Development	Proposed Liquid Waste Treatment Plant - 2018 Advice on EIS - Liquid Treatment Plant - 2021
Location	201 Five Islands Road, UNANDERRA NSW 2526

STATE SIGNIFICANT DEVELOPMENT SSD 8304 – PROPOSED LIQUID WASTE TREATMENT– REQUEST FOR ADVICE

Council comments for the proposed Liquid Waste Treatment Plant

1 % AEP Flood Depths and Spot Flood Levels (m AHD)

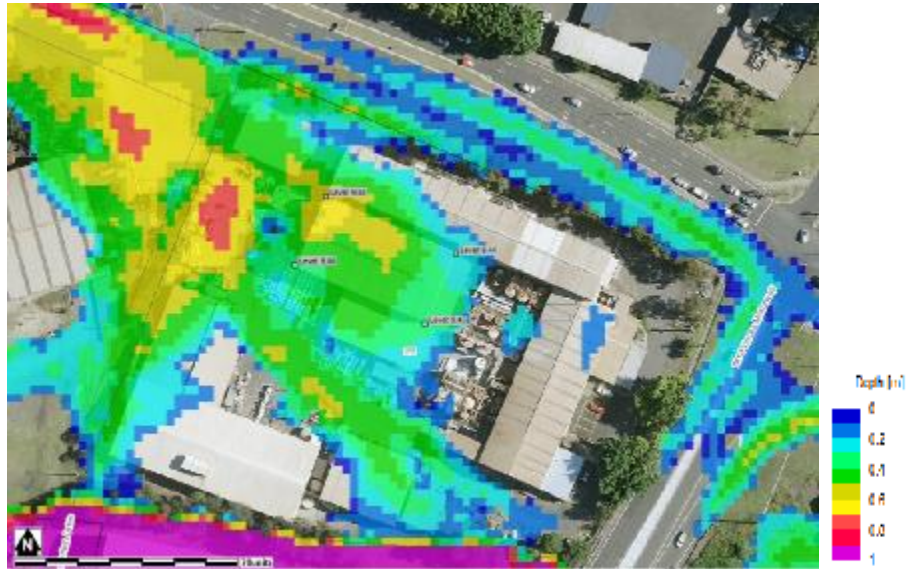
- Council's adopted Allans Creek Flood Study dated 2019 indicates a significant flood flow path through the site flowing adjacent to and around the existing building within which a liquid waste treatment plant is proposed (i.e., 'Building E'), with predicted flood levels and corresponding above floor flood depths in existing Building E being as per the table below.

10 % AEP (10 year ARI)	1 % AEP (100 year ARI)	PMF (Probable Maximum Flood)
Flood Level (m AHD)*	9.53	9.84	10.43
Above Floor Flood Depth (m)**	0.35	0.66	1.25

*The maximum flood level at Building E – predicted by Council's adopted Allans Creek Flood Study dated 2019.

**Above floor flood depth determined using the surveyed finished floor level for Building E (RL 9.18 m AHD) shown on the site survey plans appended to submitted flood risk assessment report by SitePlus.

- Council's adopted Allans Creek Flood Study dated 2019 also maps the location of Building E as a mix of hydraulic hazard category '*H2 – Unsafe for small vehicles*' and '*H3 – Unsafe for all vehicles, children & elderly*'.

- Due to the predicted flood levels, depths, and hazard through the site and within Building E (as above), the development proposal presents significant flood risks, due to potential damage to plant/equipment, machinery, etc., and pollution of the surrounding land in the event of floodwater combining with liquid waste.

- For industrial land use only – All Floor Levels to be equal to or greater than the 1% AEP flood, being equal to or greater than RL 9.84 m AHD in this instance, unless justified by site specific assessment.

- Habitable floor levels to be equal to or greater than the 1% AEP flood level plus 0.5m (freeboard), being a level of RL 10.34 m AHD. In applying this control, a habitable floor area means:

- In addition to the above and given the nature of the development and risk of environmental pollution in the event of a flood, it is also recommended that measures be integrated into the design of the development to ensure that liquid waste cannot physically come into contact with floodwaters in the event of a flood.

- Due to the flash flooding nature of the catchment, measures that rely on manual activation and/or human intervention are unlikely to be effective. The proposed method of physically segregating liquid waste from floodwaters should be failsafe and inherently integrated into the design and operation of the facility, e.g., permanent bunding with a suitable freeboard provided between the maximum flood levels and top of bund level or elevating all liquid waste treatment/storage/processing areas above the maximum flood levels such that there is no possibility of the liquid waste coming into contact with floodwater.
